DART SERVICE INSTRUCTION

TO AMEND INSTRUCTIONS FOR CONTINUED AIRWORTHINESS ICA-D350-600 REV. 4

A	NEW ISSUE	LE	07.12.21
REV.	DESCRIPTION	BY	DATE
DESIGN	<u>LE</u>	DART AEROSPACE LTD HAWKESBURY, ONTARIO, CANADA	
DRAWN	<u>LE</u>		
CHECKED	<u>PH</u>	DRAWING NO.	REV. A
MFG. APPR.	N/A	DSI 9401	SHEET 1 OF 1
APPROVED	<u>[Signature]</u>	TITLE	SCALE
DE APPR.	<u>[Signature]</u>	FASTENER REPLACEMENT	NTS
DATE	07.12.21	COPYRIGHT © 2007 BY DART AEROSPACE LTD <small>THIS DOCUMENT IS PRIVATE AND CONFIDENTIAL AND IS SUPPLIED ON THE EXPRESS CONDITION THAT IT IS NOT TO BE USED FOR ANY PURPOSE OR COPIED OR COMMUNICATED TO ANY OTHER PERSON WITHOUT WRITTEN PERMISSION FROM DART AEROSPACE LTD</small>

SECTION 'L-L' UPPER HINGE ASSEMBLY

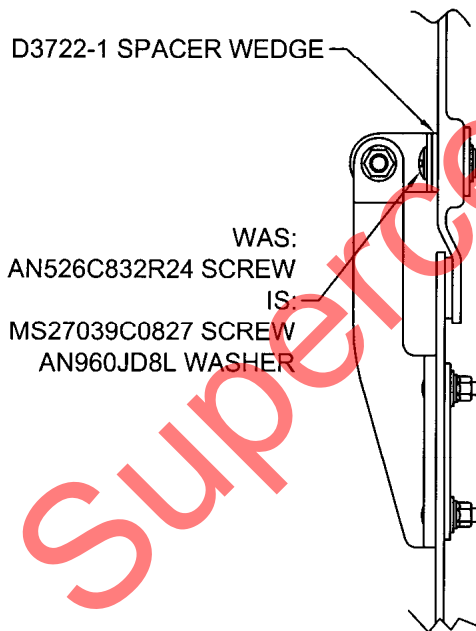
For the D355-600-243 Spacepod™ Kit B/N 36014, the AN526C832R24 screws that fasten the upper D3538-1 hinge to the Spacepod™ body have been replaced by MS27039C0827 screws with AN960JD8L washers. In addition, a D3722-1 spacer wedge was incorporated between the D3538-1 hinge and the Spacepod™ body. Section 'L-L' of Figure 10 should be updated as shown below.
